145 North Main Street

Appeal of Conditions of Approval from PA-T1-2019-00080
recommended by Historic Commission
and Ashland Department of Community Development Department

Exhibit # P-001
PA APPEAL-2019-00010/T1-2019-00080
Date 1-14-20
Staff ng

BUILDING AREAS NEEDING REPAIR

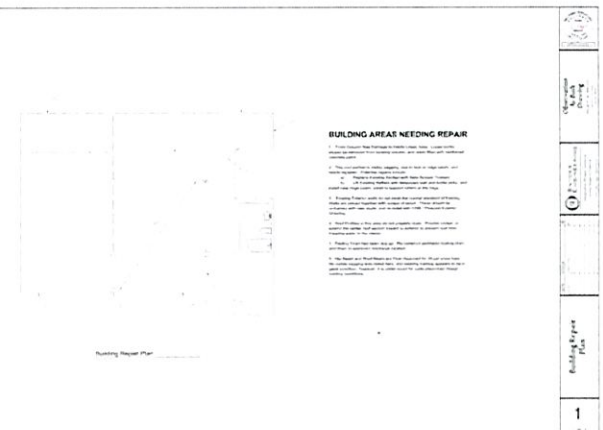
1. Front Column Has Damage to Inside Lower Area. Loose bricks should be removed from existing column, and voids filled with reinforced concrete patch.
2. This roof portion is visibly sagging, due to lack of ridge beam, and needs repaired. Potential repairs include

- a) Replace Existing Section with New Scissor Trusses
 - b) Lift Existing Rafters with temporary wall and bottle jacks, and install new ridge beam, sized to support rafters at the ridge.

3. Existing Exterior walls do not meet the normal standard of framing. Walls are pieced together with scraps of wood. These should be re-framed with new studs, and re-sided with OSB / Plywood Exterior Sheeting.

4. Roof Profiles in this area do not properly drain. Provide cricket, or extend the center roof section toward to exterior to prevent roof from trapping water in the interior.

5. Footing Drain has been dug up. Re-construct perimeter footing drain and drain to approved discharge location.
6. Hip Beam and Roof Beam are Over-Spanned for 25 psf snow load. No visible sagging was noted here, and existing framing appears to be in good condition, however, it is under-sized for code-prescribed design loading conditions.

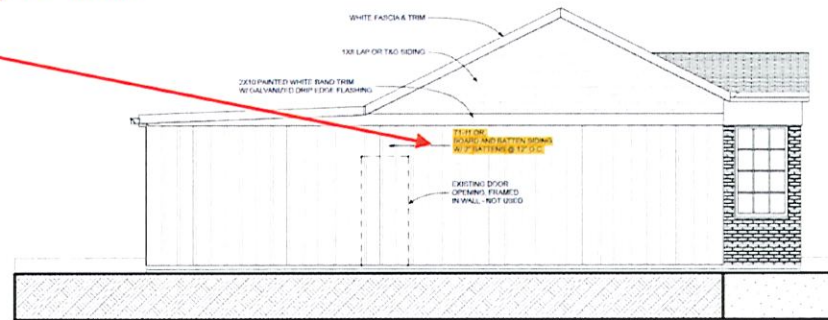
4) *Roof Profiles in this area (Over the office) do not properly drain. Provide cricket, or extend the center roof section toward the exterior to prevent roof from trapping water in the interior.*

The front roof now forms one continuous plane over the two garage bays. This plane has been continued to meet the office roof, cricketing appropriately to allow proper drainage of water.

SOUTH EAST ELEVATION-NEW

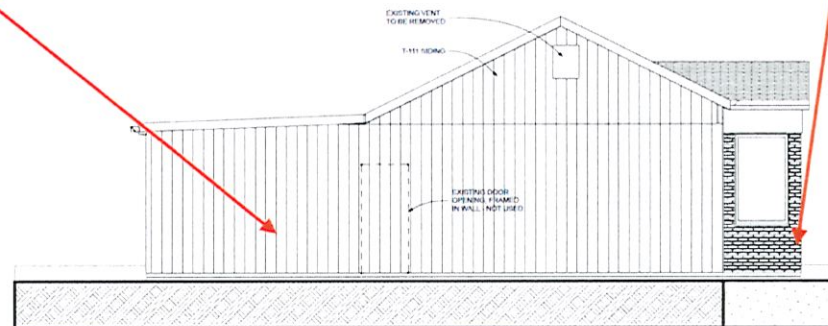
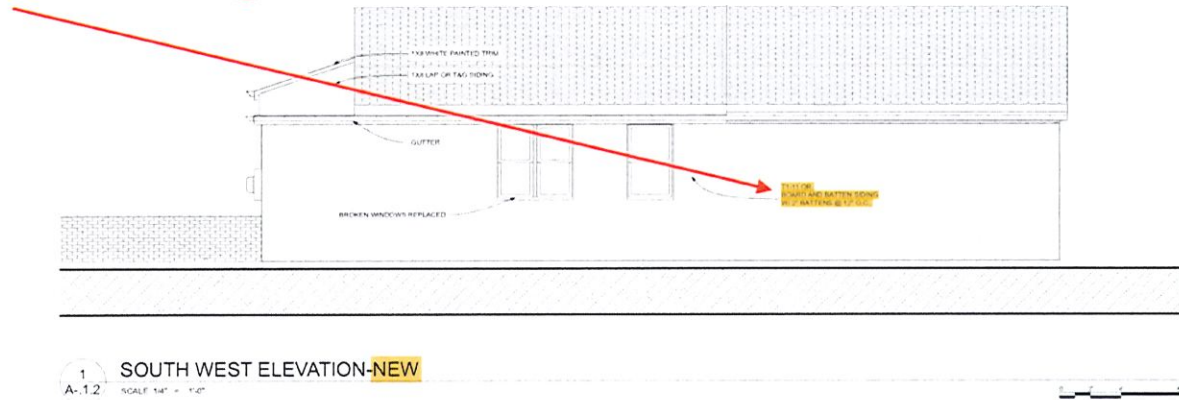
The City's Community Development Department and the Historic Commission did not effectively review the plans nor the evidence submitted which illustrated that the original siding is a combination of vertical metal siding and vertical T1-11 siding.

Compatible New Siding to match original, T1-11 OR,
BOARD AND BATTEN SIDING W/ 2" BATTENS @ 12" O.C.

NORTH WEST ELEVATION-NEW

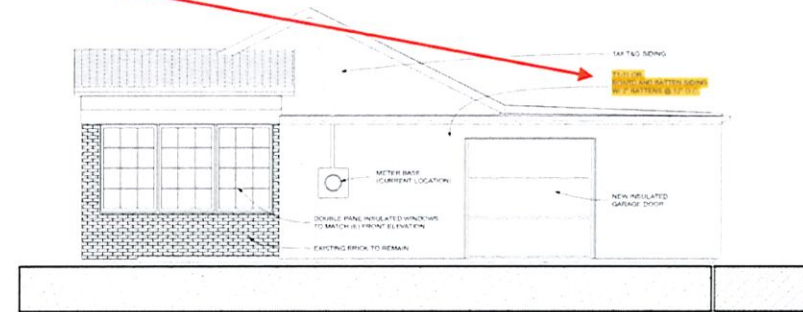
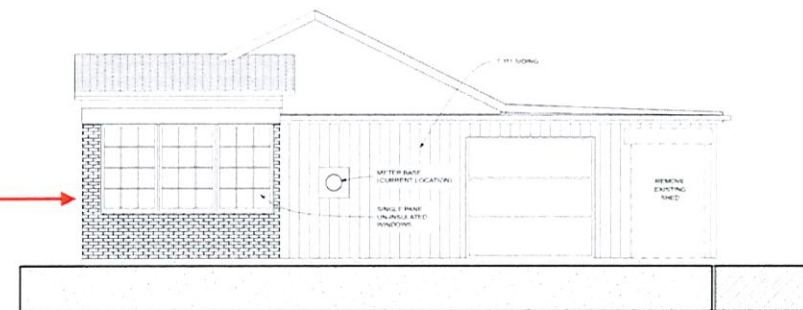
**Compatible New Siding to match original, T1-11 OR,
BOARD AND BATTEN SIDING W/ 2" BATTENS @ 12" O.C.**
